28 August 2019

Arboricultural Impact Assessment
26 Mann Street, Gosford.

I have reviewed the site survey dated 5 July 2019 by Veris, and EW Tree Impact Sections dated 26 August 2019, by DKO Architecture. These sections are attached to this report at page 11 (last page).

Plate 1—Illustrates the location of an existing excavation approximately 8m x 4m x 1.5m, and approximately 5m west of the subject fig. Note severed/torn roots at right (arrowed)

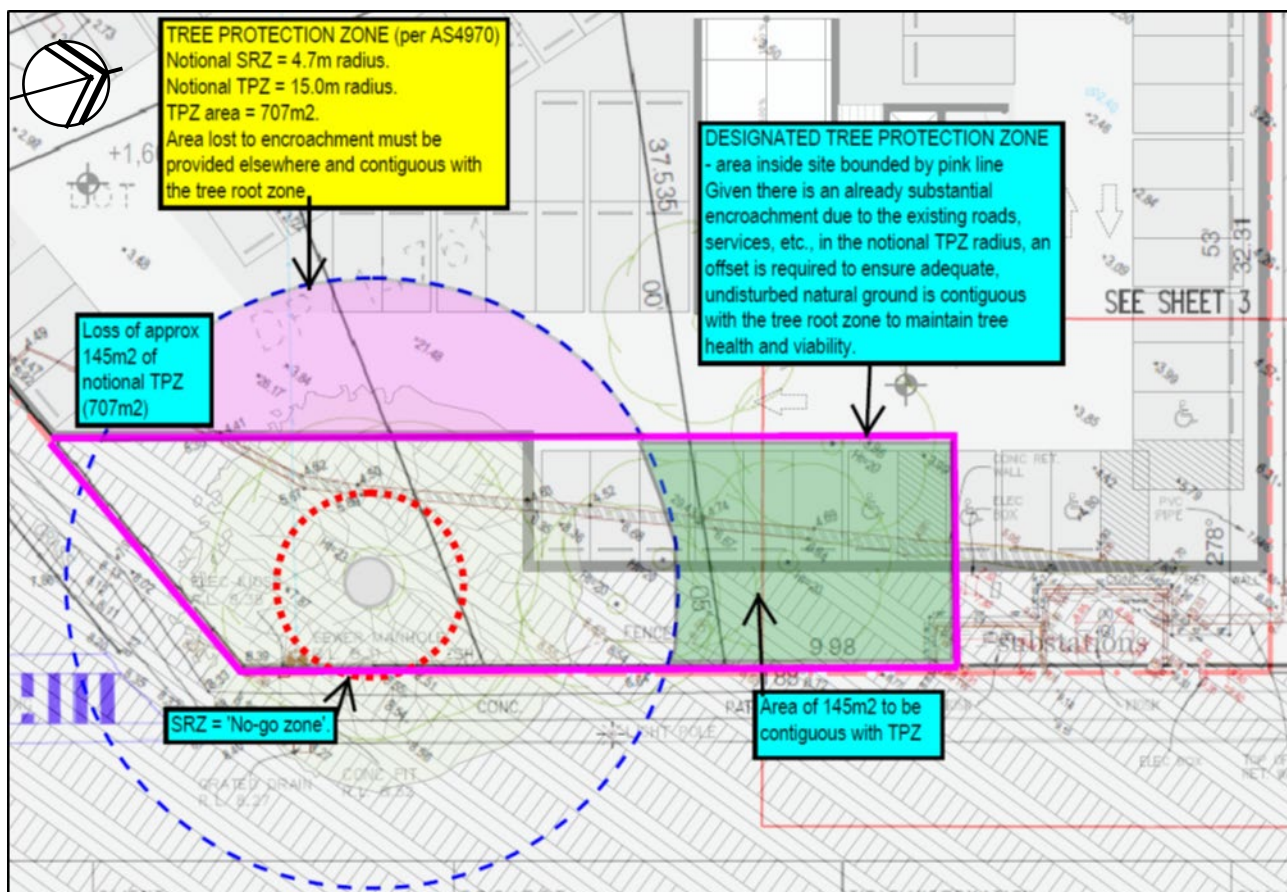
Approximately 4m west of the fig is an existing crib wall, behind which fig roots are clearly visible. West of this wall is a large rectangular depression/excavation which appears to be around 8m long x 4m wide and around 1.5m deep. There are some torn fig roots at the soil surface, just beyond the crib wall (Plate 1).

The manner in which the proposed excavation is managed to prevent further encroachment is crucial to maintaining the tree. Shoring of the sandy soil must be in place to prevent further soil collapse, and over excavation must be limited to remain clear of the crib wall. As there are fig roots entwined into and around it, this crib wall must be retained adjacent to the tree to prevent further root damage and loss, and an engineer may be required to provide advice in regard to stabilising this wall.
